Re: Proposed Tule Wind Power Project

RE: Proposed Tule Wind Power Project
Draft Environmental Impact Report/Draft Environmental Impact Statement (EIR/EIS)

EXHIBIT B

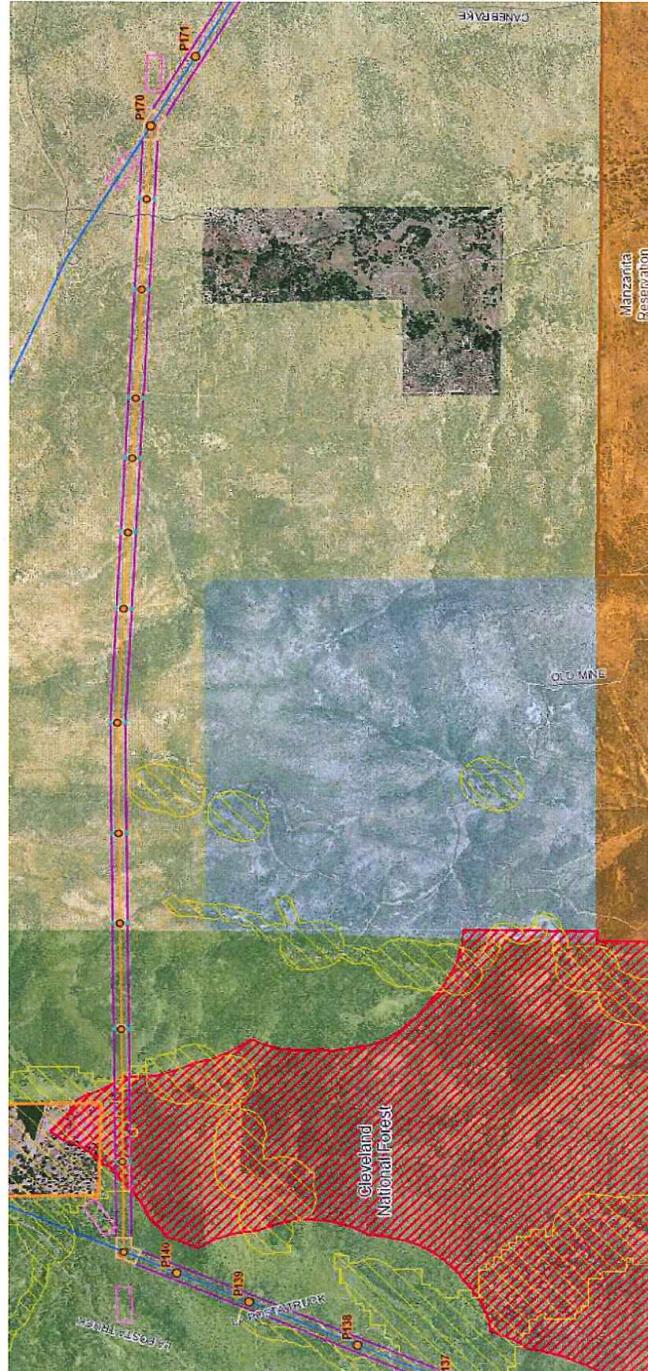
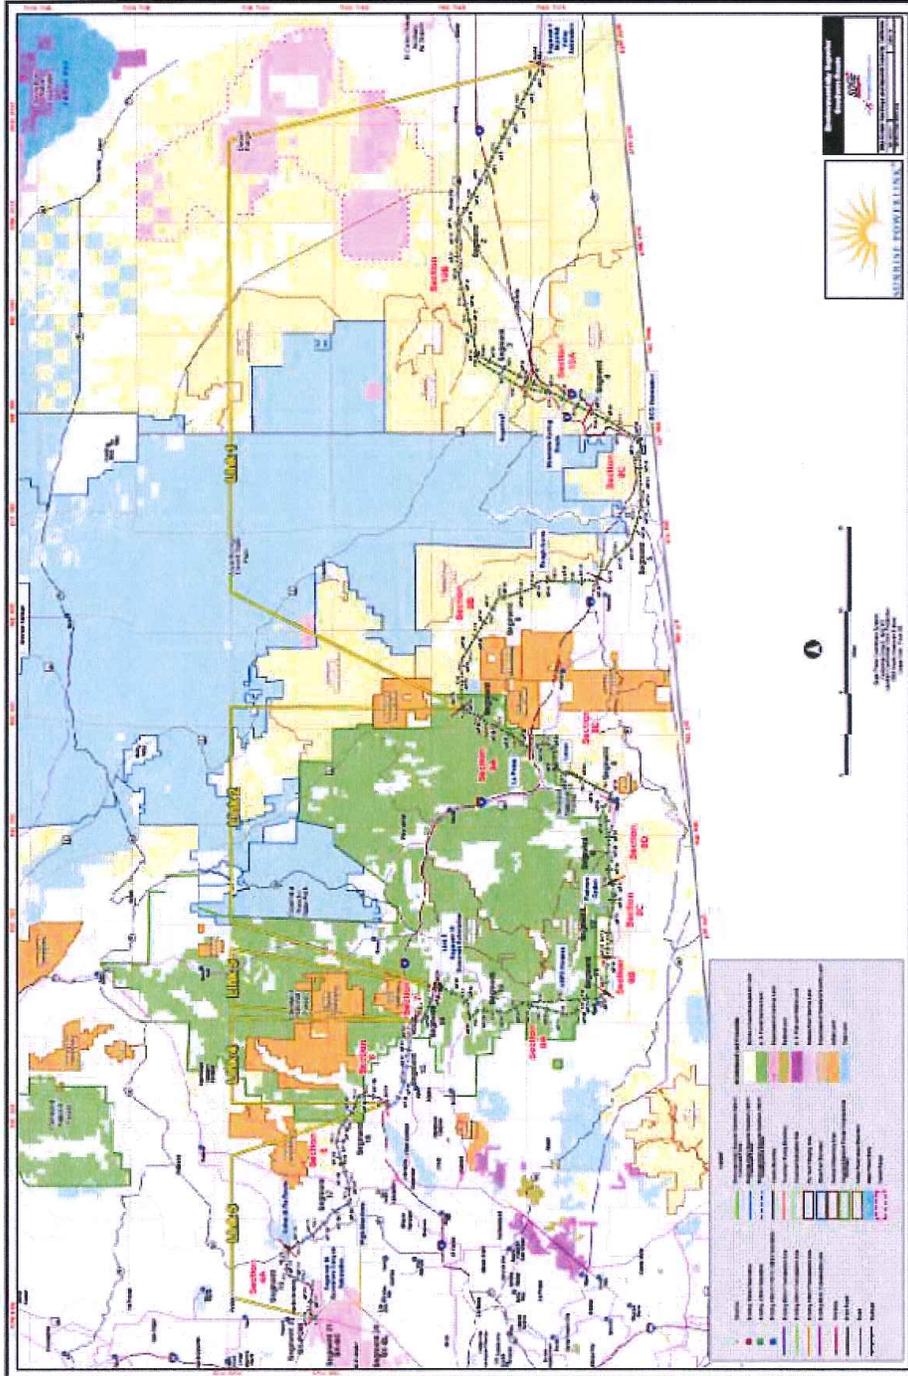
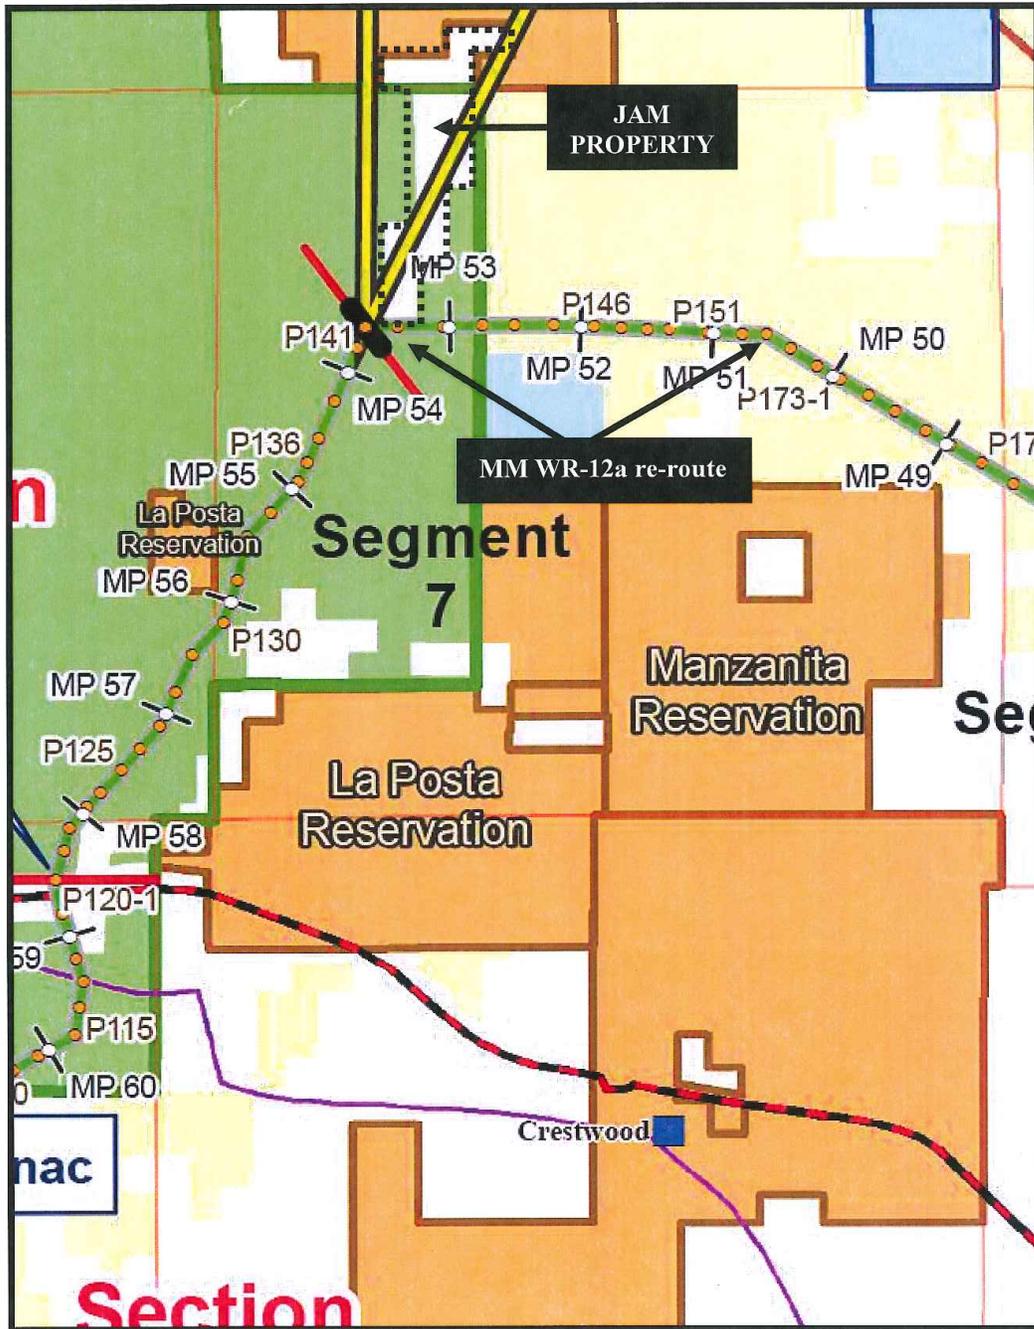
WR-2a. Develop a reroute for the BCD Alternative Revision to reduce effects on recreation. SDG&E shall relocate the overhead 500 kV transmission line along the southern boundary of JAM properties as shown in Figure E.2.1-1b to shorten the route and minimize effects on BLM land, Forest land, and private property. This reroute and its ground-disturbing components shall avoid Back Country Non-Motorized land use zones of the Cleveland National Forest, while also minimizing towers and disturbance on private property. SDG&E shall submit a memo to the CPUC for review and approval that documents its attempts to fine-tune the location of the BCD Alternative Revision, as well as the submittal of final construction plans for review and approval at least 120 days prior to the start of construction.¹

The proposed re-route submitted by SDG&E as part of the Sunrise Powerlink Project approval accomplished this task by re-routing the power lines to the south of the JAM Property. See excerpt contained at **Exhibit B**. And Figure E.2.1-1b of the Sunrise Powerlink Final EIR showing this re-route (identified as MM WR-2b re-route) is attached hereto as **Exhibit C**. This mitigation has been implemented as shown on the Sunrise Powerlink Project Segments Map dated November 2009.⁴ This document is found in full at **Exhibit D** and an enlarged excerpt showing the MM WR-12a re-route south of the JAM Property is shown at **Exhibit E**.
